Parcel 9, Phase 2 Final Plan Summary

I-195 Redevelopment District Commission
January 18, 2023

Courtyard Design Evolution

Initial Phase 2 Comments

Phase 2 Concept Plan Courtyard Options

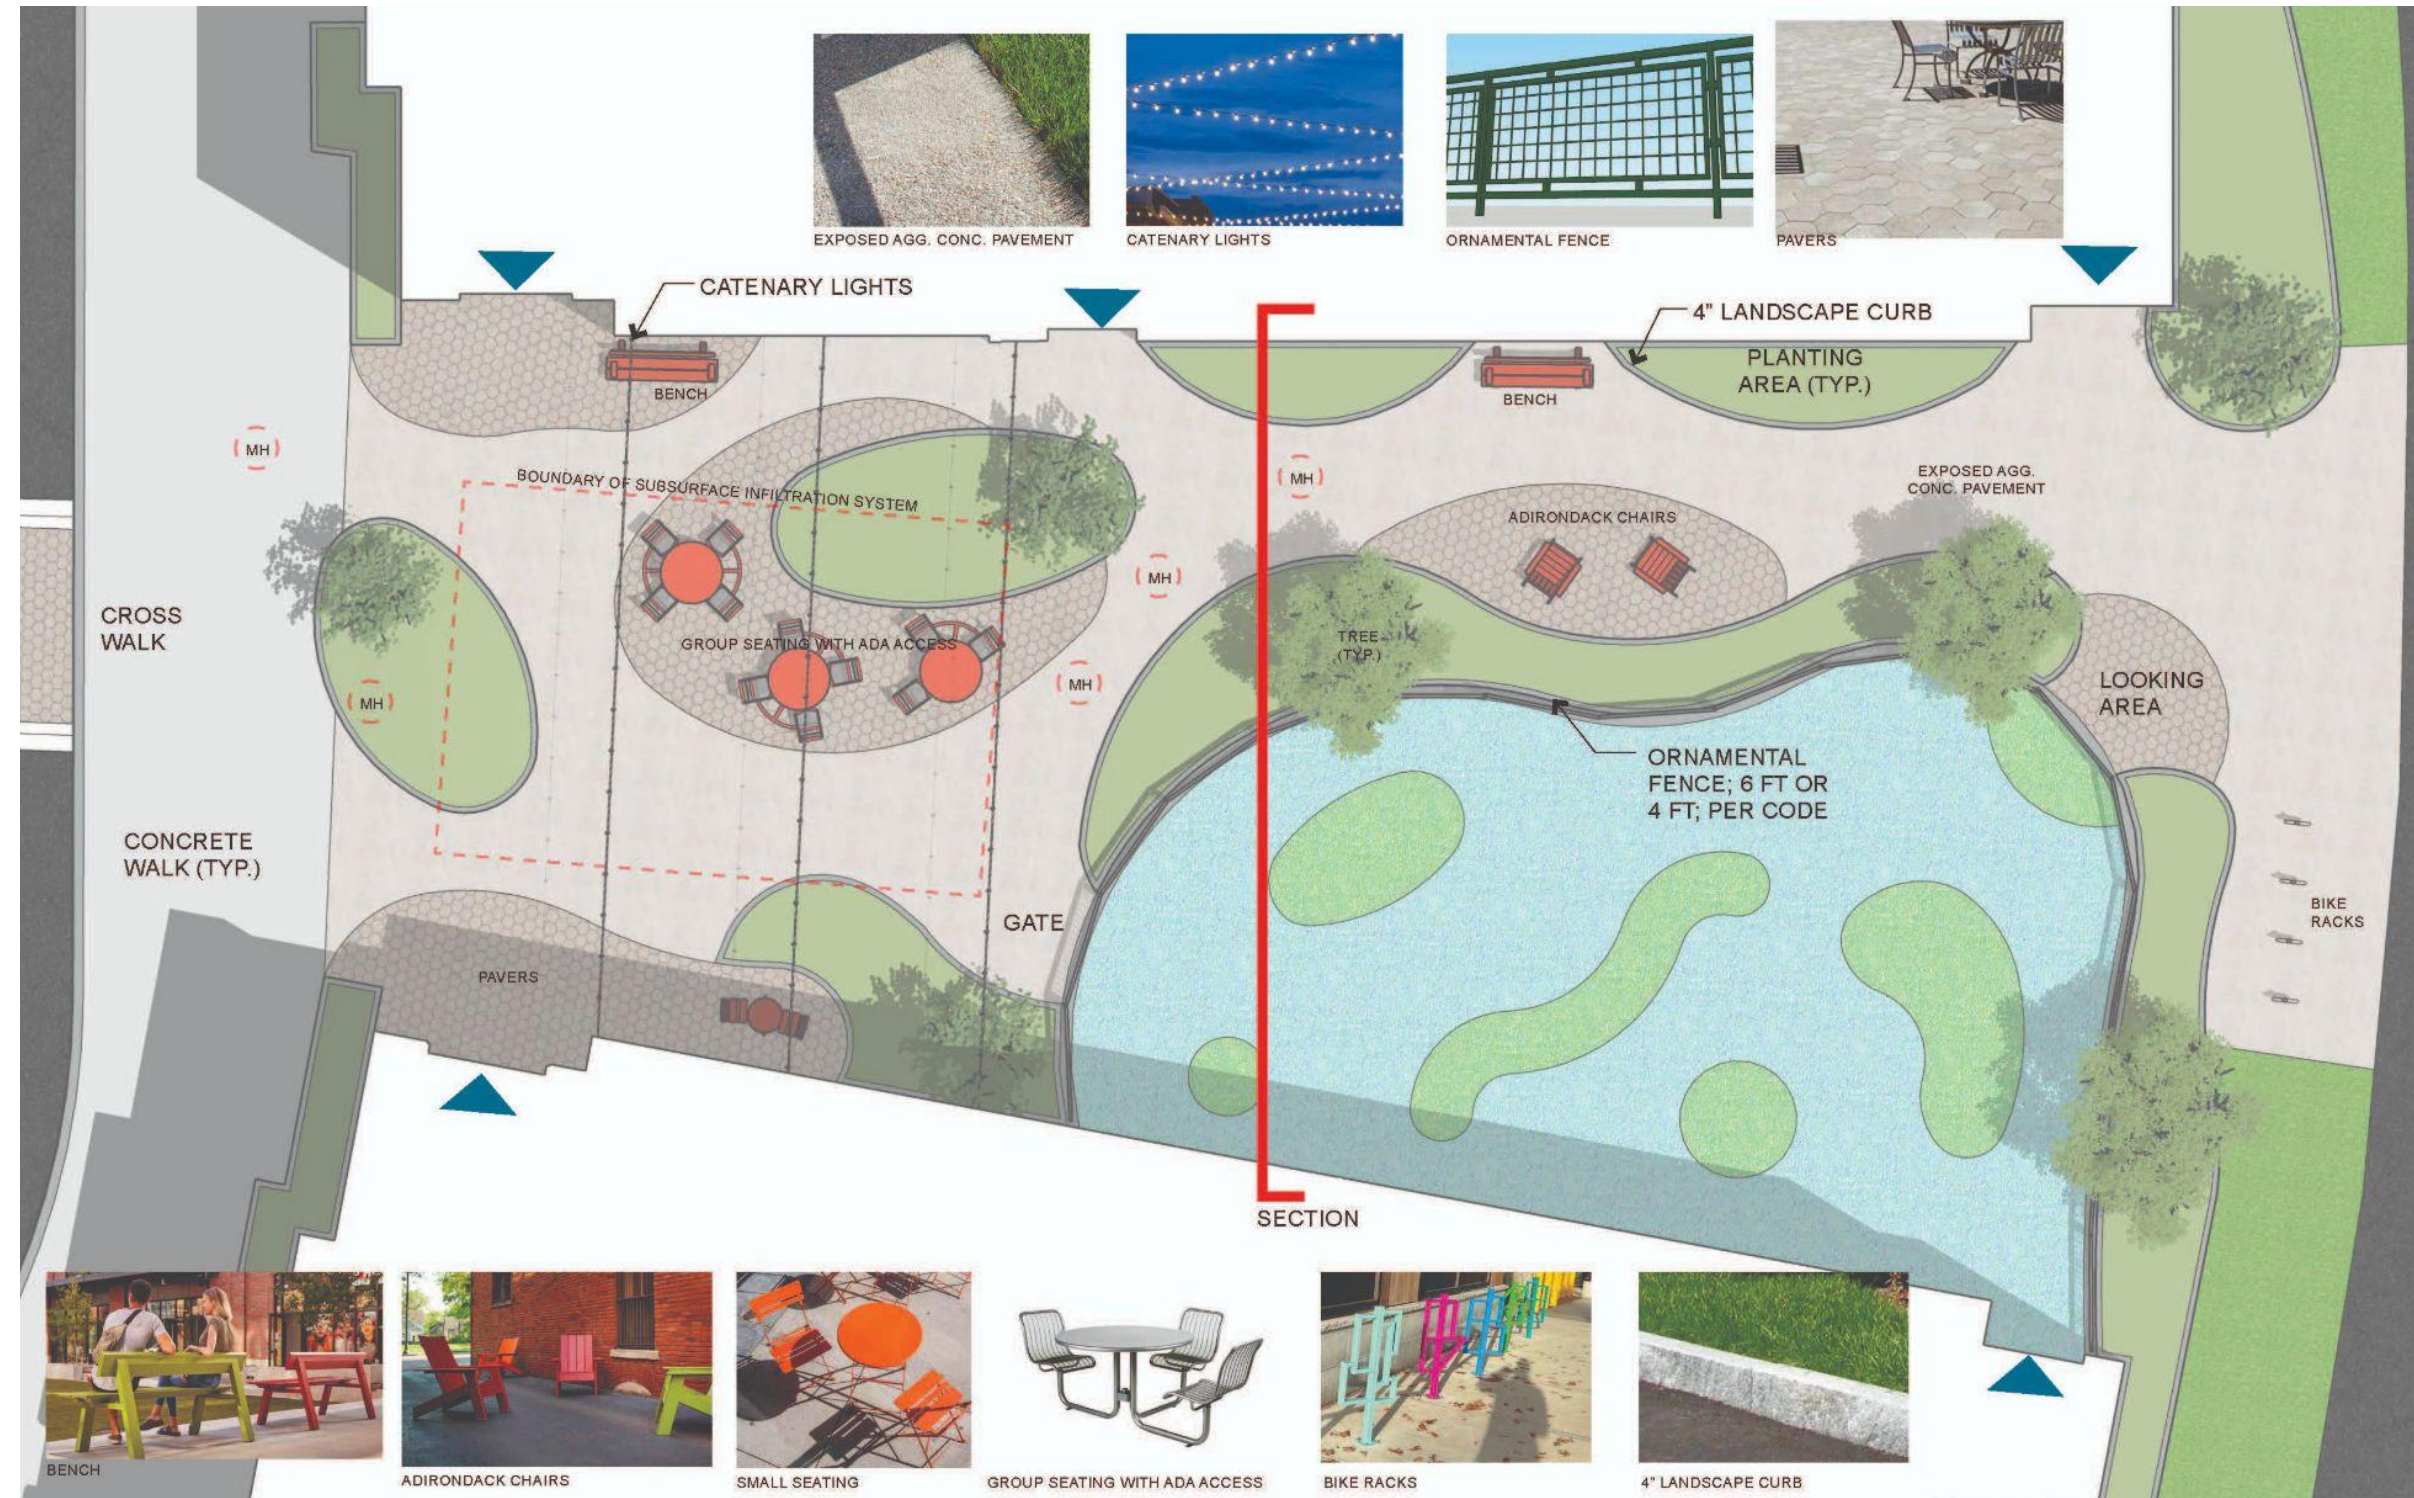
Comments about the Revisions

- More attention has been paid to the potential social life engendered by the rest of the courtyard space.
- Option 1 is preferred because it includes a diverse spaces where residents can gather outside of and distinct from the play area and the play area geometry is better-integrated into the overall composition.
- One of the seating areas allows parents to keep an eye on their children in the play area.

Suggested Courtyard Design Refinements

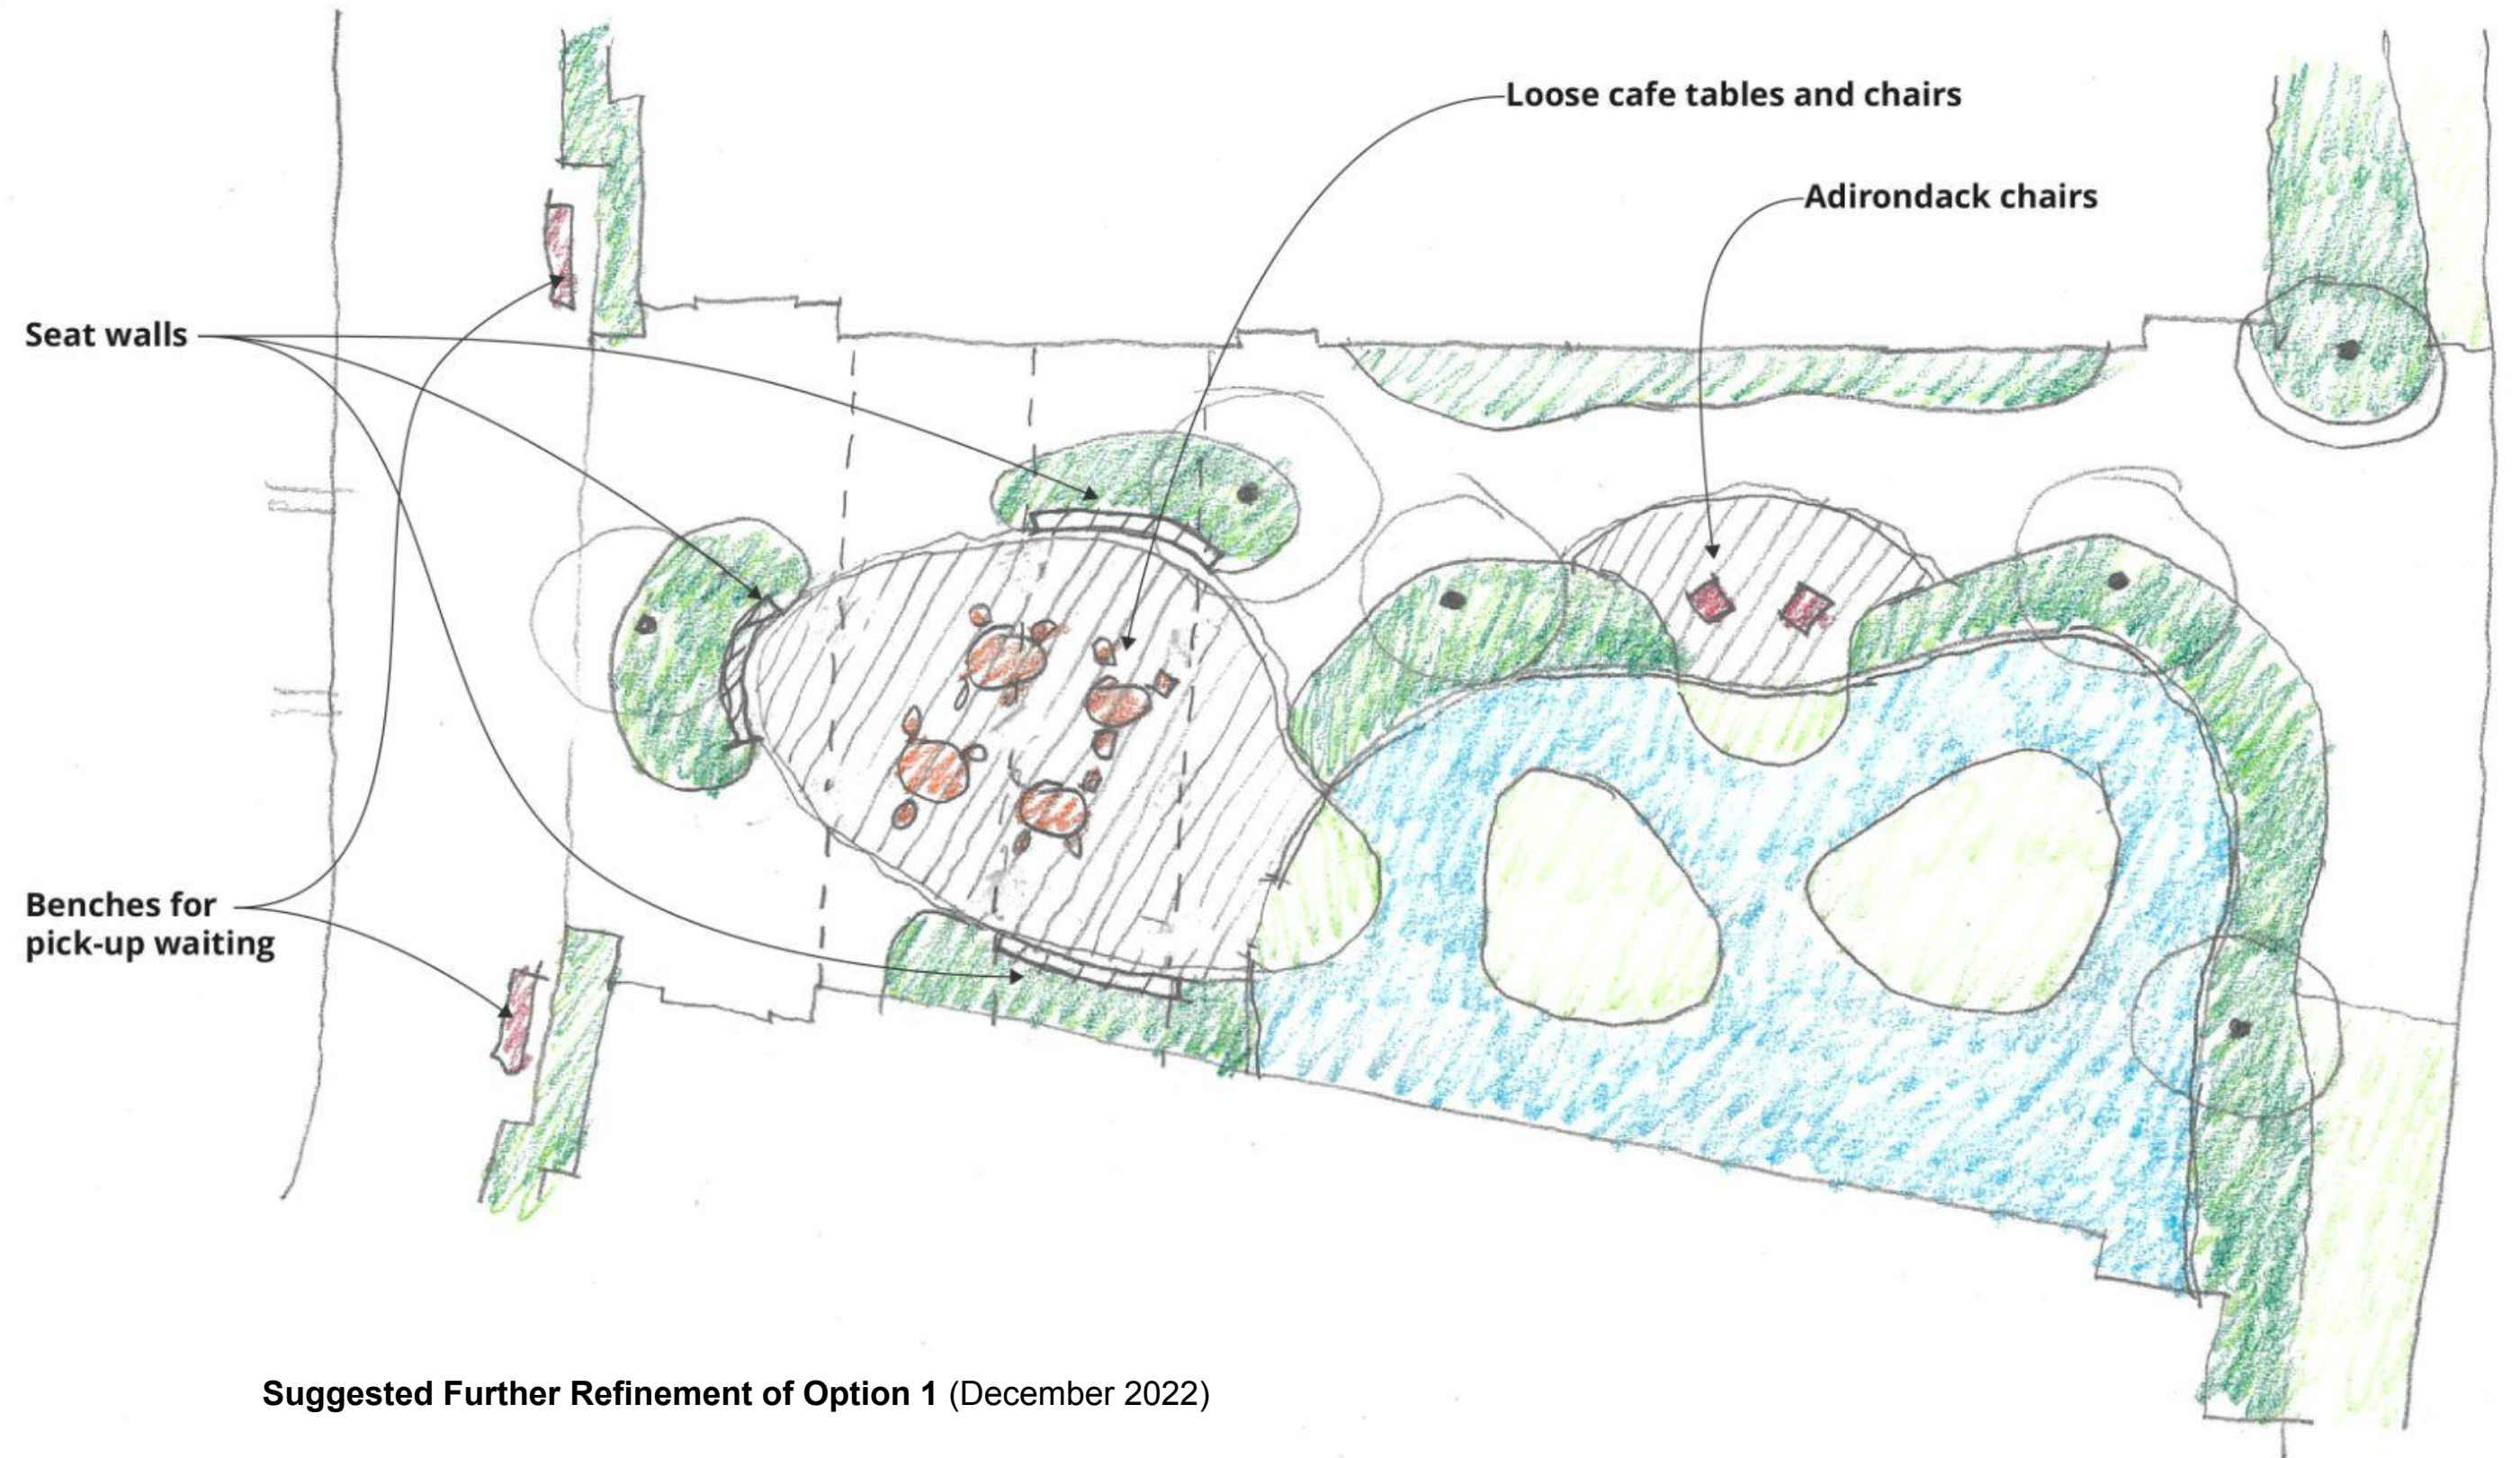
1. Clarify and focus the social idea of the courtyard on fewer, better defined spaces.
2. Create a more cohesive, streamlined furnishing strategy that reinforces the social idea.
3. Provide clarity and better visual strategy for the playground fencing.
4. Strengthen the planting strategy for all planters, especially around the playground.

Final Courtyard Design in Context

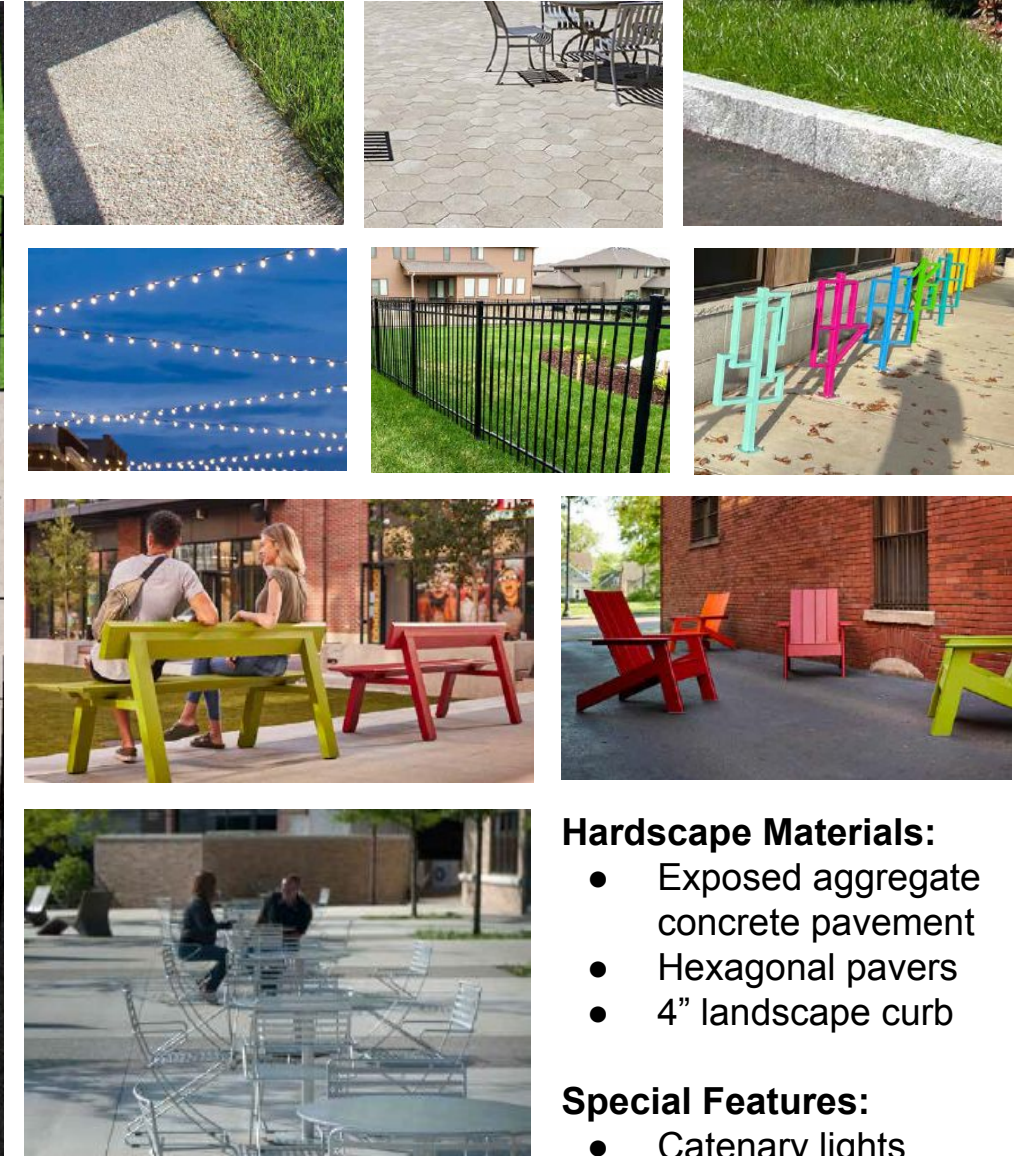
- a. Submit an updated landscape plan that accurately and comprehensively keys the planting list to the plan (including the courtyard), while also responding to the design comments in 1.b below.

- b. The plant materials depicted in the renderings are being used too decoratively and without evidence of functional considerations and/or intended spatial effects. Instead, be intentional about differentiated planting strategies for each of the specific locations:

- i. Planters that help screen and soften the play area
 - ii. Tiered plantings where City Walk meets the building edge
 - iii. Planting areas in the Courtyard at the base of Building 2

- iv. “Freeform” planters that define the sitting area behind two of the three built-in benches
 - v. The planters that create the transitions to the ground floor unit entries.

- c. Consider the seasonal impact of deciduous vs. evergreen planting materials, especially when the plantings are meant to screen views.
